Interactive comment on “Comparing hydrological modelling, linear and multilevel regression approaches for predicting baseflow index for 596 catchments across Australia” by Junlong Zhang et al.

Junlong Zhang et al.

Received and published: 14 May 2018

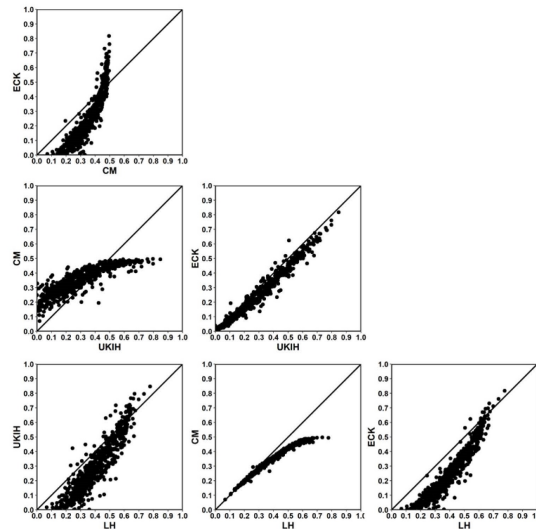
1. The implication of using the BFI ensemble mean as “observed” BFI is not discussed. The average value of BFI calculated by four methods (“ensemble mean”) is used as benchmark for evaluating the hydrologic models and regression methods. I agree that this seems to be the best choice given that no true observed BFI is available. However, a plot or statistics should be added to show the agreement among the BFI values given by the four methods. Table 3 seems to suggest significant discrepancy among the four products (My interpretation about Table 3 might be wrong, as no explanation is given in text for this table). Note that the discrepancy among the four products could be an indicator of the uncertainty associated with the ensemble mean, and should be taken into account when performing regression. For example, how does the regression residual compare with the uncertainty of ensemble mean?

Response: This is a very good suggestion regarding the uncertainty from the four methods. It is indeed that there are large difference between the four methods, as shown in the following new Figure 1 (the number will be renamed in next version).

In order to eliminate uncertainties from the four algorithms, it is necessary to use the ensemble mean of the four method estimates as the benchmark (denoted as ‘the observed BFI’) to evaluate multilevel regression and linear regression approaches. We also add one scatter plot to show the BFI derived from four methods.

New Figure 1. Baseflow index derived from four non-tracer baseflow separation methods and ensemble mean value. LH, UKIH, CM, ECK and Mean are the baseflow index estimated from Lyne-Hollick (Lyne and Hollick, 1979), UKIH (Gustard et al., 1992), Chapman-Maxwell (Chapman and Maxwell, 1996), Eckhardt (Eckhardt, 2005) methods. To show more information on the statistics, we add Table 3 (Thanks for picking up that the explanation for Table 3 has not been provided) to show regression approaches (linear regression and multilevel regression) performances when compared to each BFI method. We also use standard deviation to present uncertainty of ensemble mean to evaluate the regression approaches (linear and multilevel).

New Figure 2. The difference of NSE and Bias between calibration and validation for linear regression approach ((a) and (c)) and multilevel regression approach ((b) and (d)).

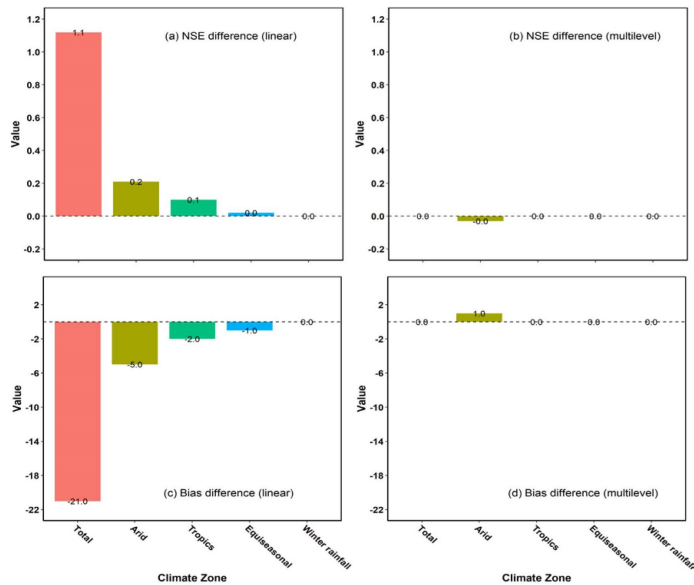
Line 356. Figure 7 shows the validation results, which support the conclusion that multilevel regression outperforms classic linear regression. However, this is not the case for Figure 6, which is based on the data used for regression. Multilevel regression uses more parameters, so it is anticipated that it will fit the data better.

Response: What you are said is true. The main point is for prediction (i.e. the results shown in Figure 7). Another important point the initial version is not clear the degradation from calibration to validation for both linear regression and multilevel regression approaches (as shown in new Figure 2 (this will be renumbered in the next version)).

New Figure 2 summarises the degradation from calibration to validation for the two regression approaches. First, multilevel regression is very stable and there are no noticeable degradation across all climate regimes. Second, there exists strong degradation for linear regression, and the degradation is much stronger for the whole dataset

than for the sub datasets (i.e. data from different climate regimes). Third the degradation for the linear regression is stronger in arid and tropics climate regimes than in Equiseasonal and Winter rainfall climate regimes.
